SUBJECT: CONFIRMATION OF CHANGE TO TECHNICAL SPECIFICATIONS (TAC 69804)

RE: SALEM GENERATING STATION, UNIT 2

SUBJECT: CONFIRMATION OF CHANGE TO TECHNICAL SPECIFICATIONS (TAC 69804)

Figure 3.2-3
RCS TOTAL FLOWRATE VERSUS R - FOUR LOOPS
IN OPERATION

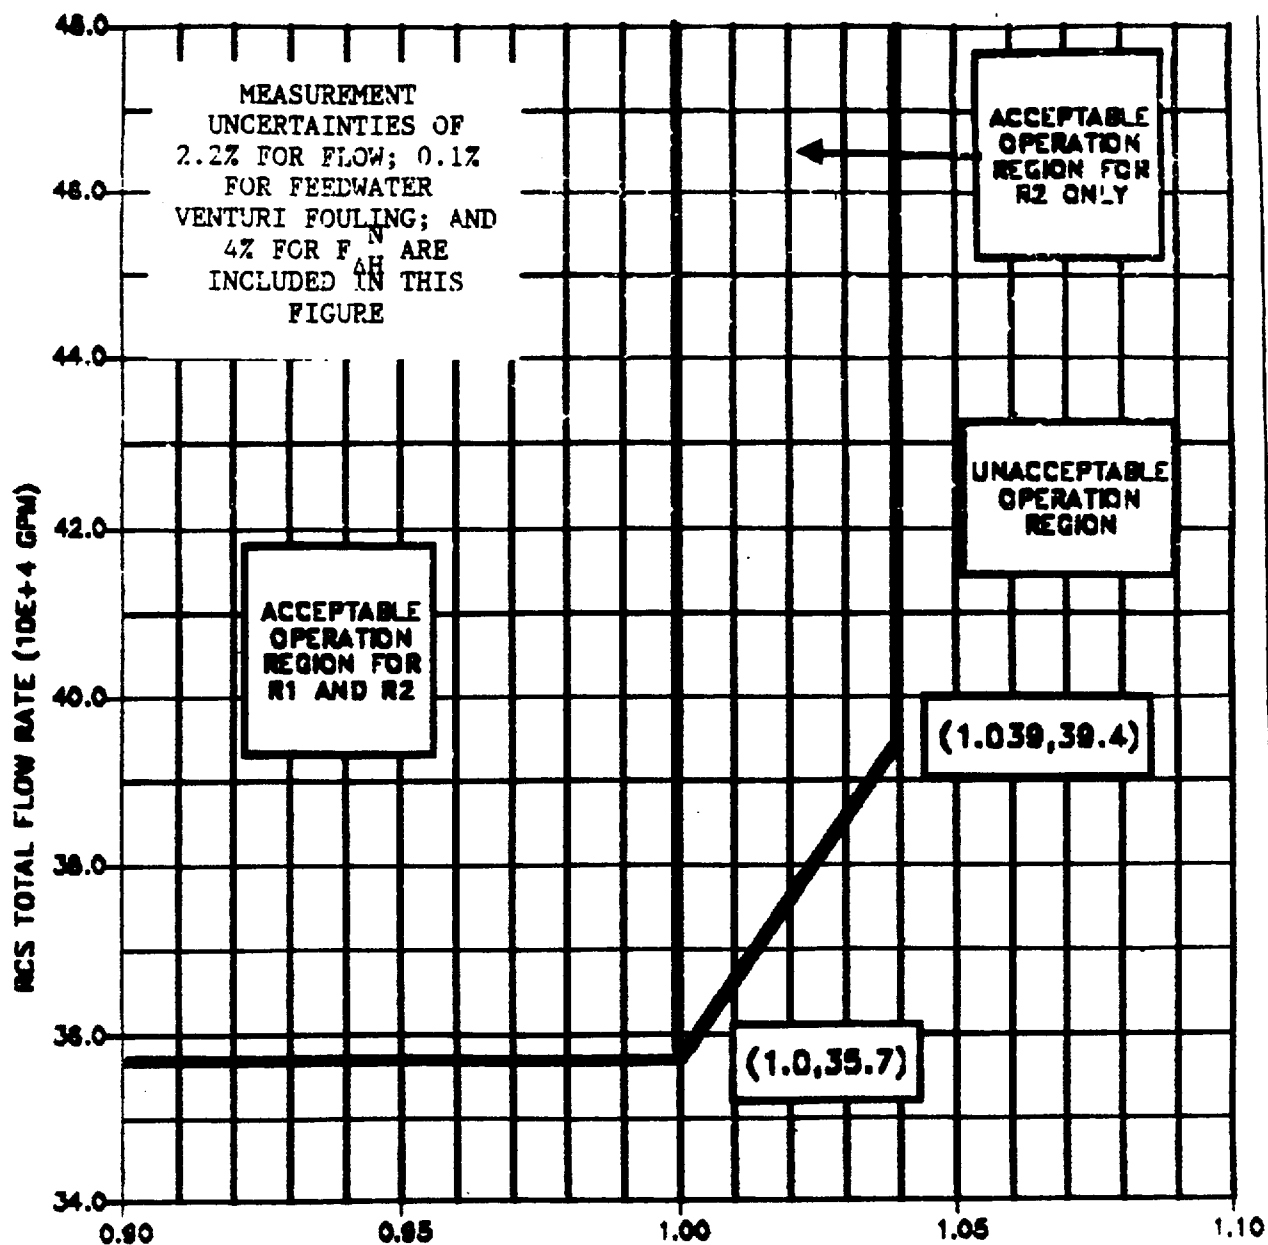
3.2.3 The combination of indicated Reactor Coolant System (RCS) total flow rate and R_1 , R_2 shall be maintained within the region of allowable operation shown on Figure 3.2-3 for 4 loop operation.

d. $F_{\Delta H}^N$ = Measured values of $F_{\Delta H}^N$ obtained by using the movable incore detectors to obtain a power distribution map. The measured values of $F_{\Delta H}^N$ shall be used to calculate R since Figure 3.2-3 includes penalties for undetected feedwater venturi fouling of 0.1% and for measurement uncertainties of 2.2% for flow and 4% for incore measurement of $F_{\Delta H}^N$.

When RCS flow rate and $F_{\Delta H}^N$ are measured, no additional allowances are necessary prior to comparison with the limits of Figure 3.2-3. Measurement errors of 2.2% for Reactor Coolant System total flow rate, 0.1% for feedwater venturi fouling, and 4% for $F_{\Delta H}^N$ have been allowed for in the determination of the design DNBR value.

$$R1 = F_{\Delta H}^N / 1.48[1.0 + 0.3(1.0 - P)]$$

$$R2 = R1 / [1 - RBP(BU)]$$
